## **RESOLUTION NO. 2011-576**

### **ADOPTION OF THE 2010 URBAN WATER MANAGEMENT PLAN**

Re: Comments on the Consultant's Draft 2010 Urban Water Management Plan (July 2010)

Subject: Comments on the Draft 2010 Urban Water Management Plan

Figure 6-1. Historical Per Capita Water Demand

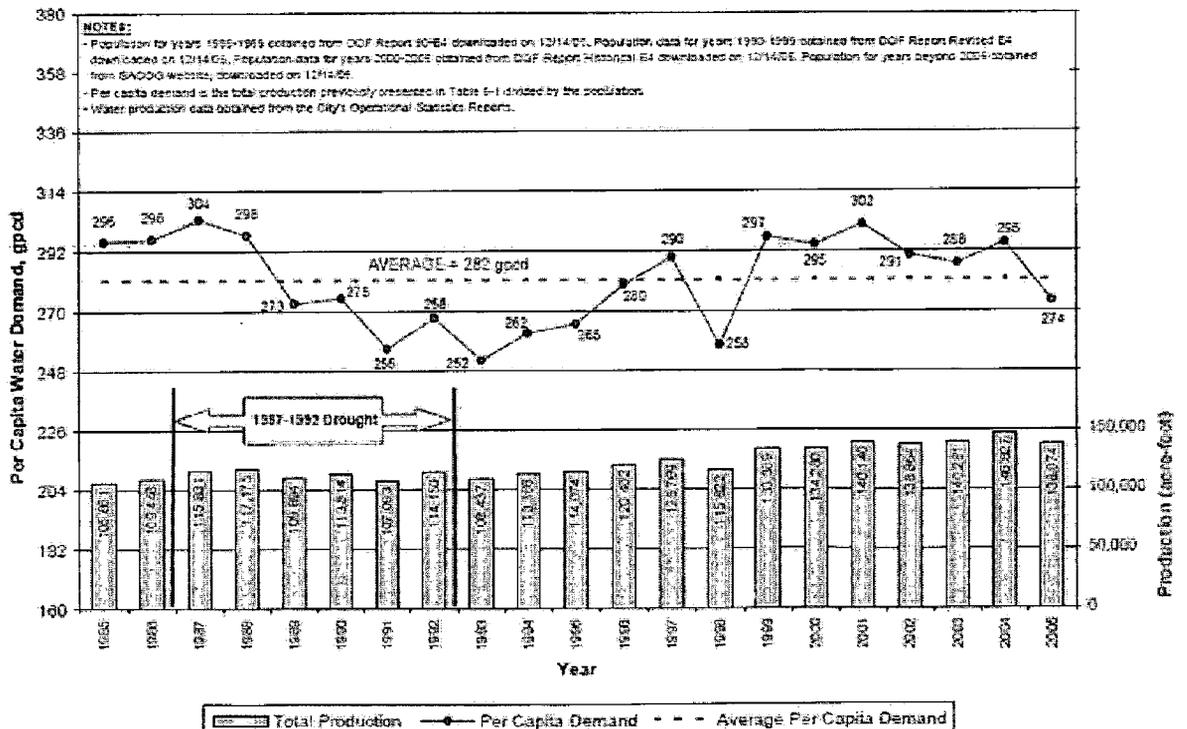
In the 2005 UWMP, however, the reader can find a historic per capita use chart clearly indicating the water use patterns of residents of Sacramento.<sup>iv</sup>

Your letter notes that the 2005 UWMP included a chart showing historic per capita water demands indicating the water use patterns of residents of Sacramento, although no such chart is included in the 2010 Plan. The comment seems to suggest that this was done to hide "the fact that Sacramento has over time done very little to reduce its per capita use of water."

We agree that a similar chart would be helpful to better understand the City's recent water consumption. Staff will have the Plan revised to include the chart set forth below. No attempt was made to hide the City's recent per capita use of water, which has declined, as indicated in the Plan and shown on the chart below.

Figure 6-3. Projected Water Demands

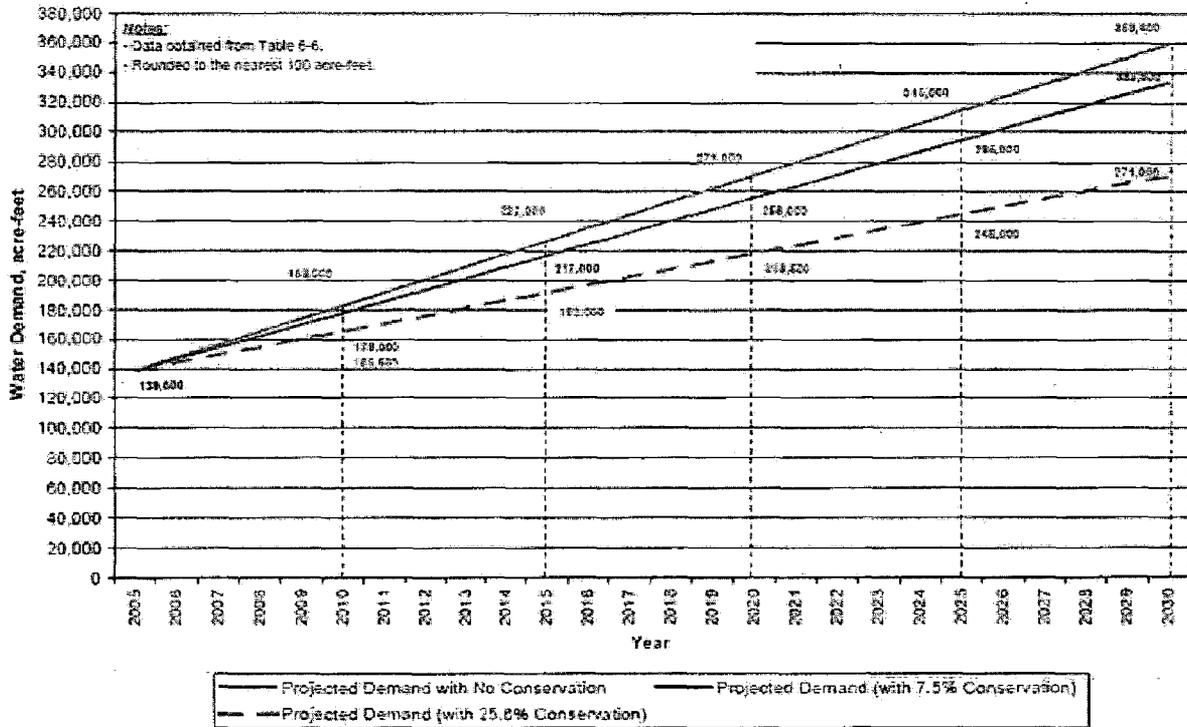
In the 2005 UWMP you find a chart that compares projected water demands to available supply.<sup>v</sup> There is nothing comparable in the 2010 consultant draft and there should be.

Your letter refers to a chart in the 2005 UWMP that compared projected water demands to available supply, and states that a comparable chart should be provided in the 2010 Plan.

*A chart similar to the one provided in 2005 is presented below and will be included in the Final UWMP. It should be noted that the chart presented in the 2005 UWMP included demand estimates under various conservation scenarios including no conservation, 7.5 percent conservation and 25.6 percent. The below chart assumes 20 percent conservation from recently calculated demands, based on current State law requirements. As previously noted, nothing in the Plan precludes the City from achieving a greater reduction than is required under State law.*
